Statutory Road Hump Notice Responses

Proposal Reference Number – R0003

Street – Oakwood Court (north and south arms)

Title of Proposal – Statutory Notice for Road Humps

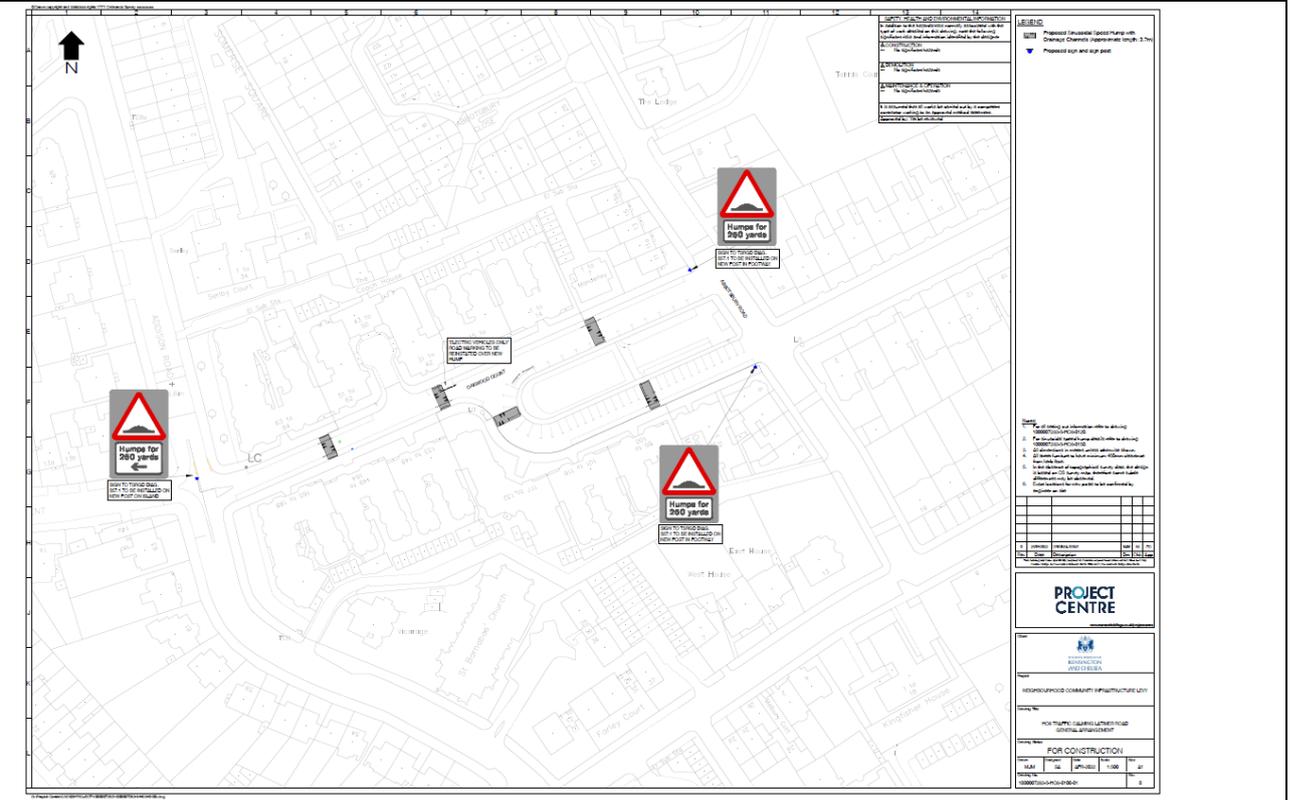
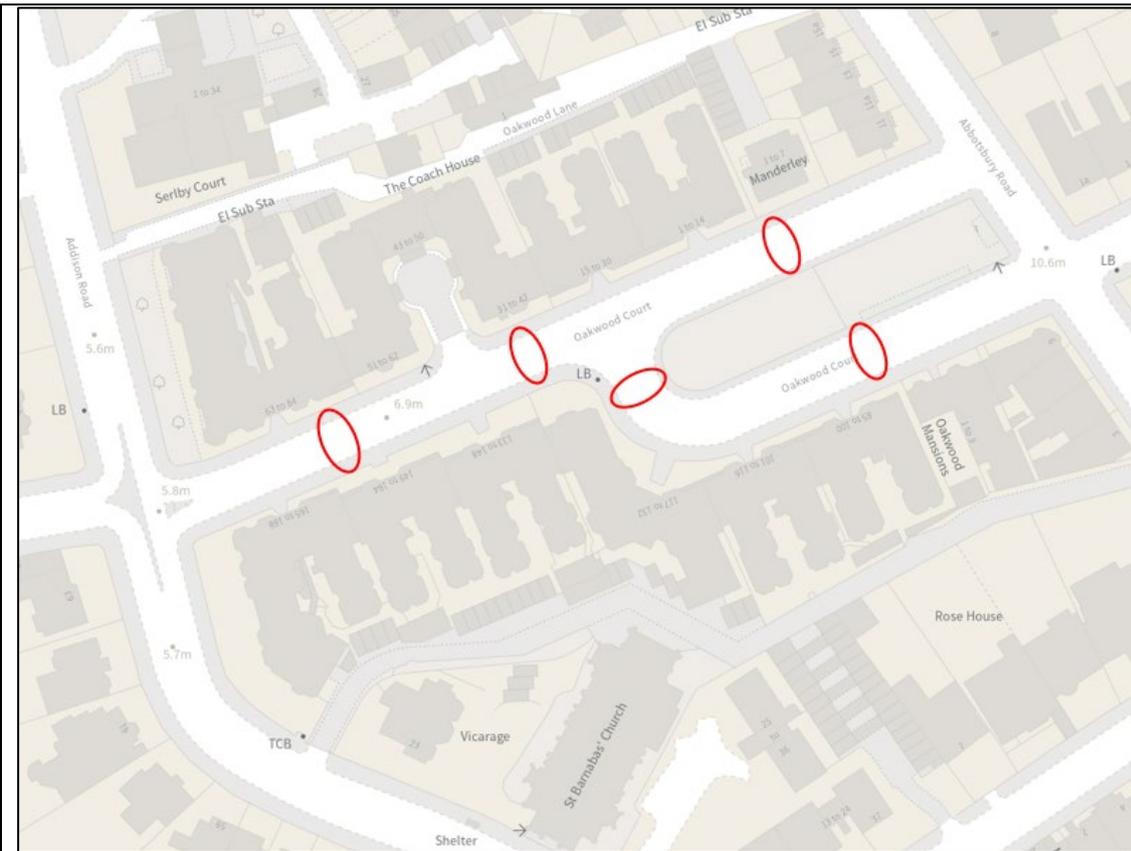
“As a local resident who cycles and drives regularly along the road outside Oakwood Court, I object to the proposal to put in humps along this road for the reason that I think that they would be an unnecessary waste of money. This is a relatively short stretch of road, and should not require humps to control traffic speeds. In my experience, there is not a problem of speeding here.”

“We write in support of the installation of the proposed traffic-calming measures on Oakwood Court. Oakwood Court, like the streets called Holland Park, comprises residential streets and, like Holland Park, should not be capable of being used as a high-speed cut-through for commuter traffic.”

“Many thanks for the email. The Met Police have no objection or observation to add with regard to the proposals.

I would be interested to see any follow up speed surveys post implementation.

This road hump scheme is a result of an application for NCIL funding by the Oakwood Court Residents Association for traffic calming on Oakwood Court to address concerns that drivers were speeding on Oakwood Court and using it as a cut through. The application was subsequently approved by Holland ward councillors. The ringfenced NCIL funds are specifically reserved for schemes requested by local residents. As this scheme was a resident-led initiative, it was not subject to our usual policy tests for the installation of road humps, such as a proven history of speeding or personal injury collisions.

Following the successful application we held a local consultation on the proposed scheme, which involved a letter drop of 248 letters. 82 per cent of the respondents to the consultation supported the scheme and the decision to proceed was taken by the Lead Member for Planning, Place and Environment, ward Councillors and the Council's Director for Streets and Regulatory Services.

Regarding the objector's concerns regarding the road humps, the Council intends to install sinusoidal road humps, which have a smoother profile than 'standard' round topped humps and provide a smoother ride when cycling over them and reduce noise from vehicles.

With regards to the allocation of funds, should this scheme not go ahead the funds would return to the NCIL funding pot, to be allocated during the next round of NCIL applications.

The council do not currently have any plans for follow up surveys, but there is a benefit in monitoring the changes in driver behaviour along these roads.

The council run regular batches of traffic surveys and will consider adding Oakwood Court into the next batch of surveys, following implementation of the road humps. If the council do gather any further traffic data, it will be shared with the Met Police.

should proceed as originally advertised.
